Site Accessibility Evaluation

Americans with Disabilities Act Title II (Public Services: State and Local Government)

DOT Operations Center

**3275 Akers Dr
Colorado Springs, CO
80922**

Finding: 1

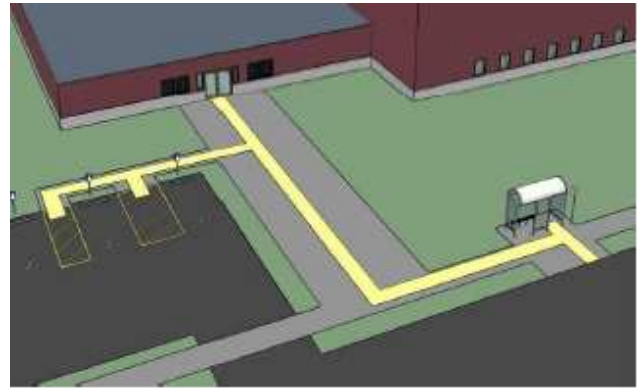
The accessible parking is not located on an accessible route of travel to the accessible building entrance.

Pedestrian ramp does not align w/aisle

Submit w/o for correction. Area needs to be re-striped and access aisle to sidewalk path of travel needs to align w/accessible ramp.

Corrective Action: Parking area was repaved to meet seamless transition from access aisle to access route. Corrected 18 Oct 2016.

Finding: 2

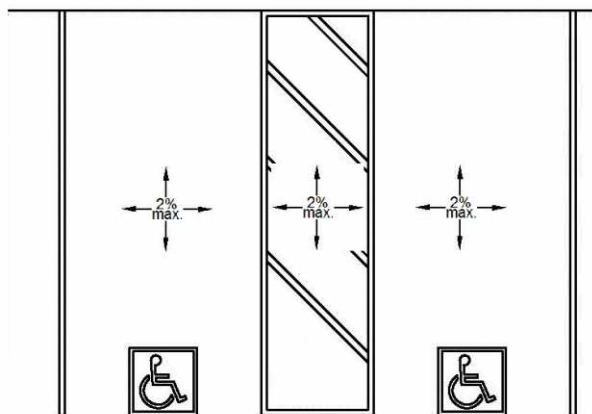
The running slope of the access aisle (long dimension) exceeds 2%.

Running slope ranges
from 1% and 9.5%

Re-pave access aisle and ensure a 2% maximum cross and running slope for the full length and width of the access aisle.

Finding: 3

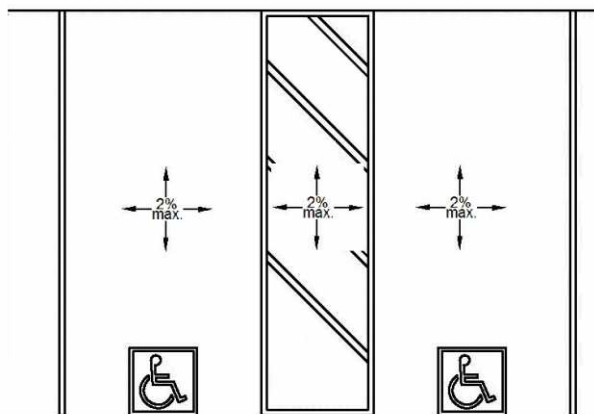
The running slope (long dimension) of the accessible parking stall exceeds 2%.

Running slope ranges
from 1% up to 9.5%

Re-pave designated ADA parking stalls and ensure a 2% maximum cross and running slope for the full length and width of the parking stalls.

Finding: 4

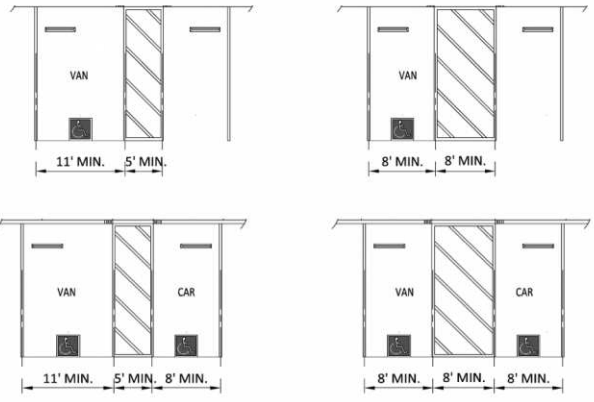
The accessible parking stall is not wide enough.

Van parking stall
measures 9.8 feet in
width

Re-stripe ADA parking stall/s and access aisle/s. ADA parking stalls shall measure 8 ft minimum in width measured to the centerline of the paint stripes. Access aisles shall measure 5 ft minimum in width measured to the centerline of the paint stripes. Ensure ADA van parking stall/s are 8 feet wide minimum with an access aisle of 8 feet wide minimum or 11 feet wide minimum with an access aisle of 5 feet wide minimum measured to the centerline of the paint stripes.

Finding: 5

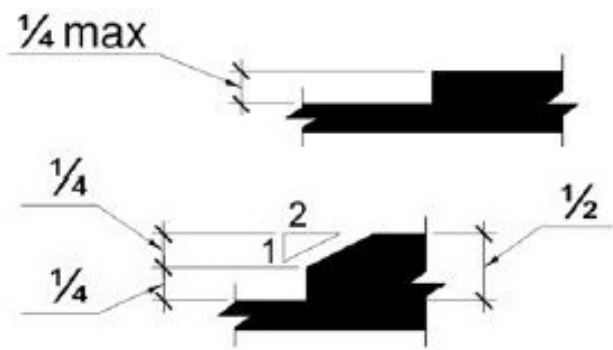
The walkway contains abrupt vertical edges and/or variations over a 1/4 inch.

3/4 of an inches upheaval.

Submit a work order to have sidewalk area shaved.

Finding: 7

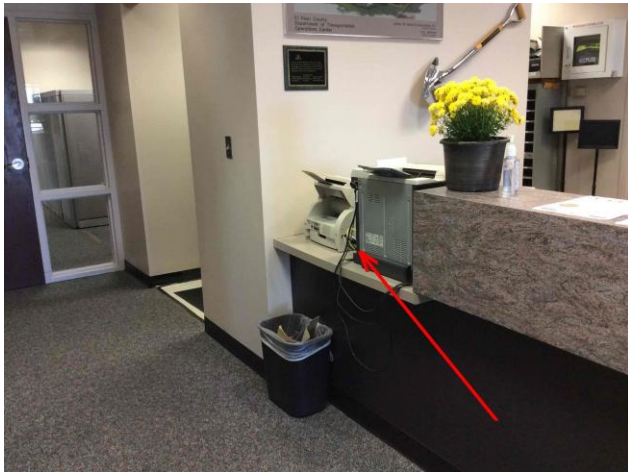
Counter not accessible due to fax/printer.

Not accessible due to fax/printer on accessible counter area

Relocate fax/printer in order to clear counter for service.

Corrective Action: Relocated to provide clear counter area on 18 Jan 2017.

Finding: 8

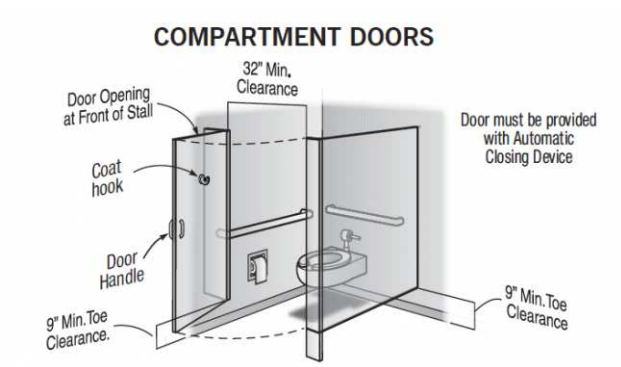
The compartment door is not self closing.

Compartment door not self closing

Adjust or install automatic closing hinges.

Corrective Action: W/O 381195 submitted.

Finding: 9

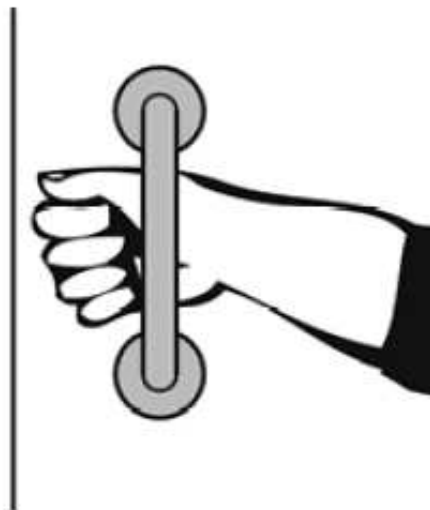
The water closet compartment door is missing a loop handle on the inside.

Missing inside loop handle on compartment door

Install loop or U-shaped handle on inside of compartment door.

Corrective Action: W/O 381194 submitted. Installed loop handles on inside/outside of stall door-completed 3/10/2017.

Finding: 10

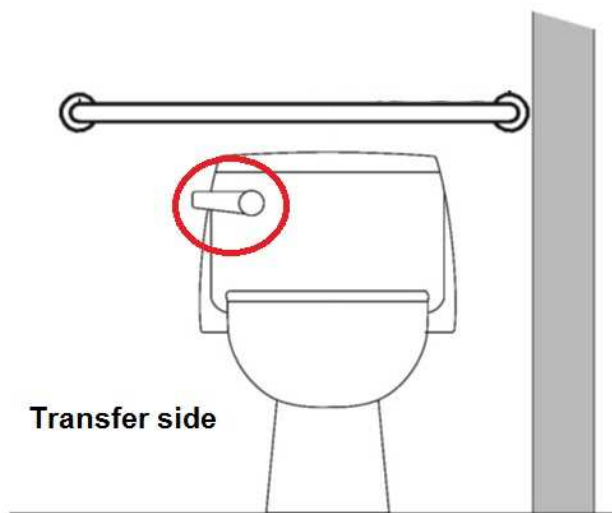
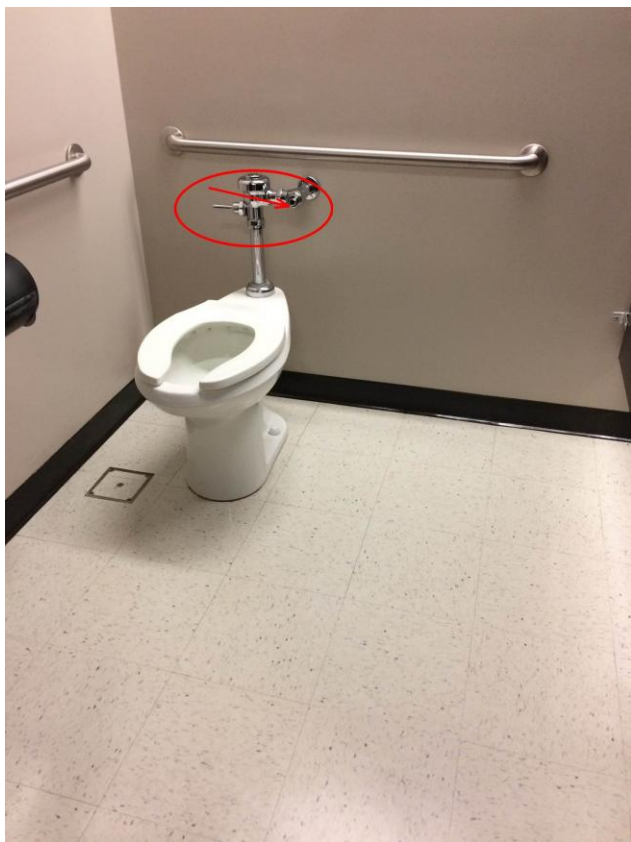
The flush handle is located on the wrong side of the toilet.

Flush handle located
on closed side

Relocate flush handle to opposite side (open side of toilet area).

Corrective Action: W/O 381193 submitted. Installed new sensor type flush valve 3/14/2017.

Finding: 11

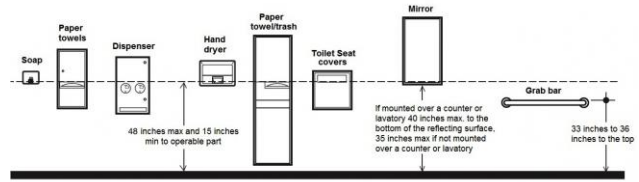
The toilet seat cover dispenser is mounted too high.

53 inches above
finished floor

Re-locate toilet seat cover dispenser below either grab bar at least 1.5 inches minimum below grab bars but no less than 15 inches above finished floor to meet compliance.

Corrective Action: W/O 392073 submitted. Relocated seat cover dispenser-Completed, 3/10/2017.

Finding: 13

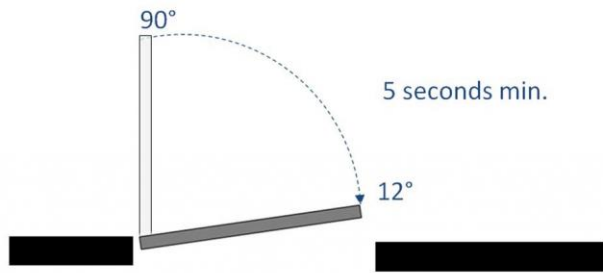
The door is equipped with a door closer and returns to a closed position too quickly.

Door from hallway to vestibule closed in 1.38 seconds and door from vestibule to restroom closed in 2.14 seconds.

Adjust both door closers to allow a minimum of 5 seconds to move from the open position at 90 degrees to 12 degrees from the latch/locking mechanism.

Corrective Action: W/O 386077 submitted.

Finding: 14

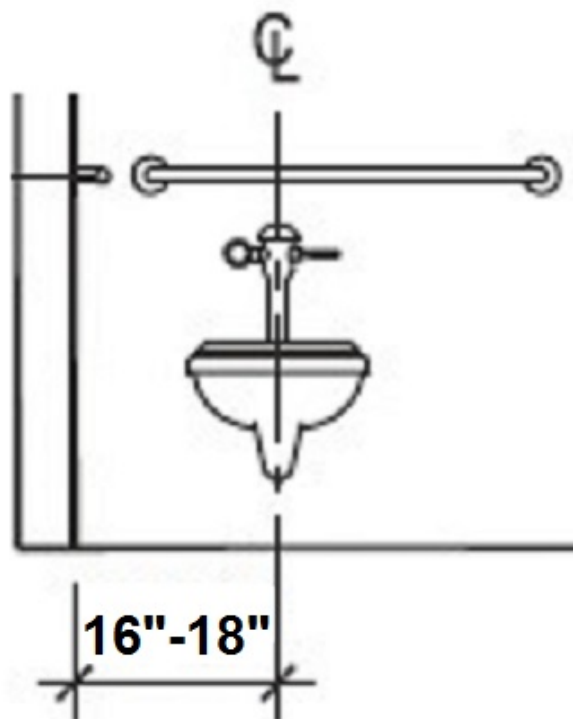
The toilet is not located within the range allowed from the side wall or partition.

18.5 inches from side wall

Re-position toilet between 16 inches minimum and 18 inches maximum from centerline of toilet to side wall. May require plumbing alteration.

Finding: 15

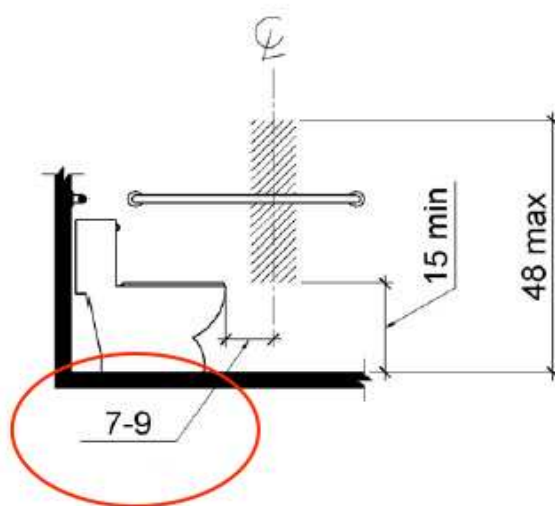
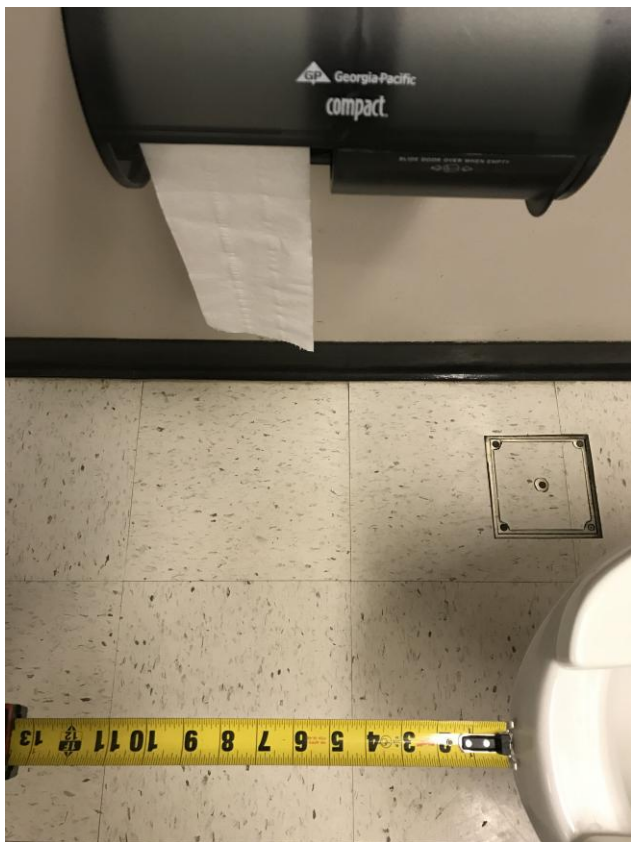
The toilet paper is not installed within the compliant range.

5 inches in front of toilet

Re-position toilet paper dispenser to be within 7 inches minimum to 9 inches maximum in front of the toilet measured to the centerline of the dispenser.

Finding: 16

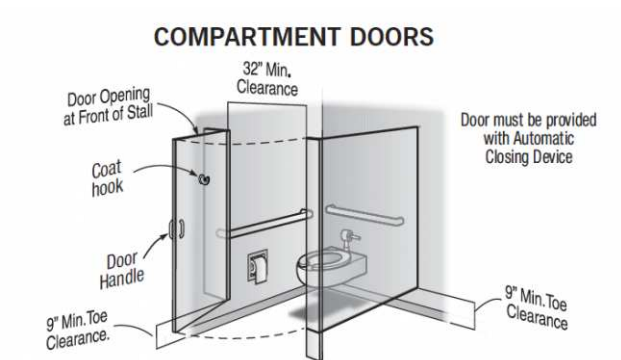
The compartment door is not self closing.

Compartment door not self closing

Adjust or install automatic closing hinges.

Corrective Action: W/O 381190 submitted.

Finding: 17

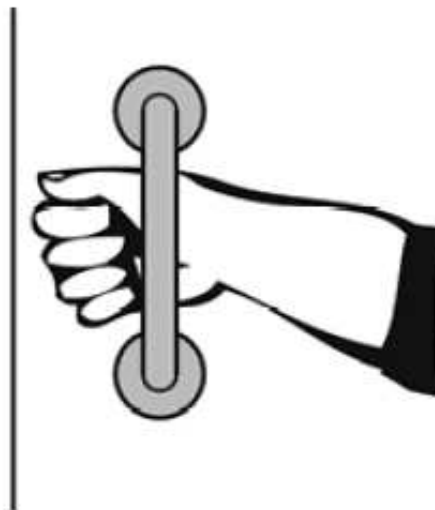
The water closet compartment door is missing a loop handle on the inside.

Missing inside loop handle on compartment door

Install loop or U-shaped handle on inside of compartment door.

Corrective Action: W/O 381188 submitted. Installed loop handles on inside/outside of stall door-completed, 3/10/2017.

Finding: 18

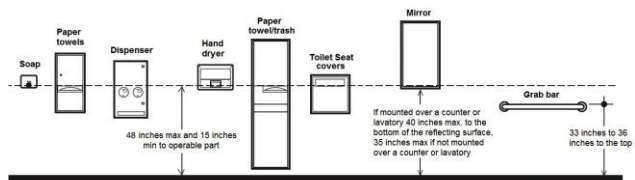
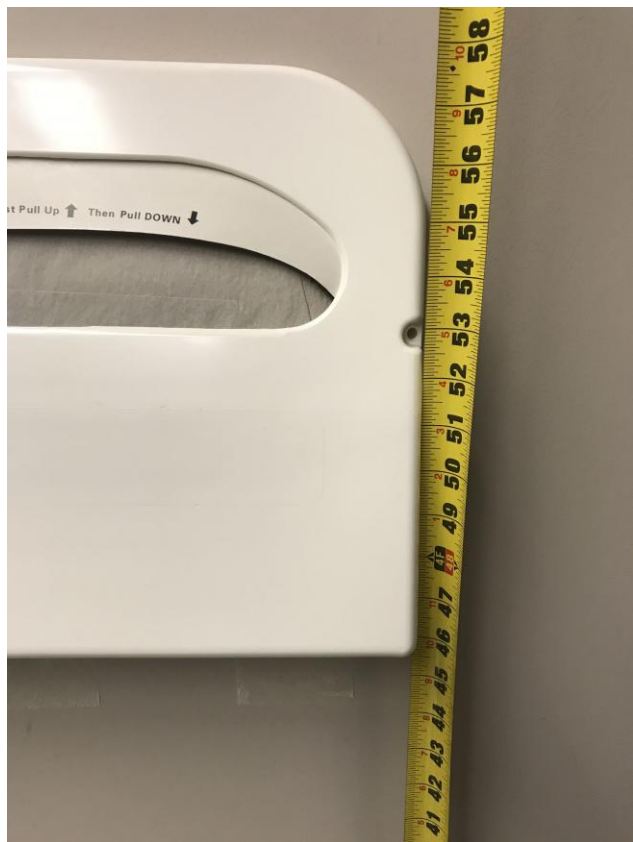
The toilet seat cover dispenser is mounted too high.

53 inches above
finished floor

Re-locate toilet seat cover dispenser below either grab bar at least 1.5 inches minimum below grab bars but no less than 15 inches above finished floor to meet compliance.

Corrective Action: W/O 392072 submitted. relocated seat cover-completed 3/10/2017.

Finding: 21

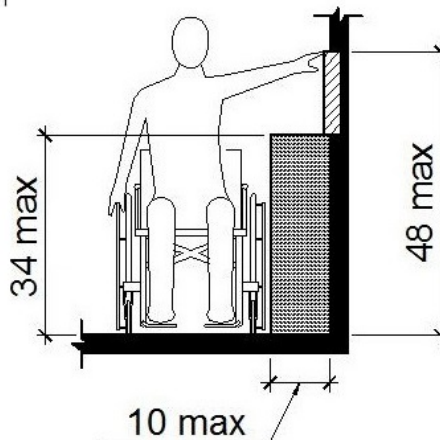
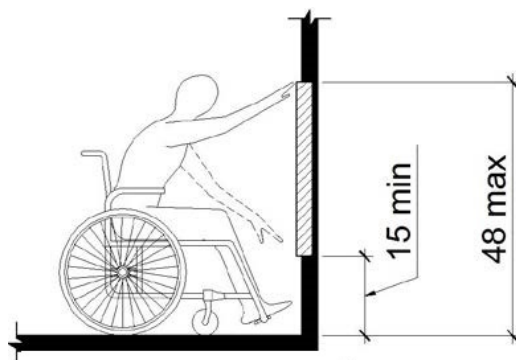
The coat hook is installed greater than 48 inches above the finished floor.

58 inches above
finished floor
